Volvo Cars of North America, LLC

RE: RECALL 189

85 - 189

Recall 189, Labels Integrated Booster Cushion (IBC), Replacing

Transfer the clips

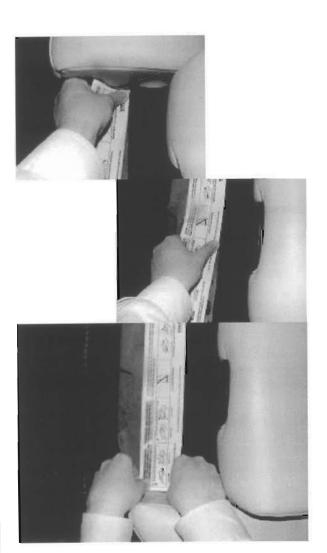
Transfer the clips from the old label to the new one.
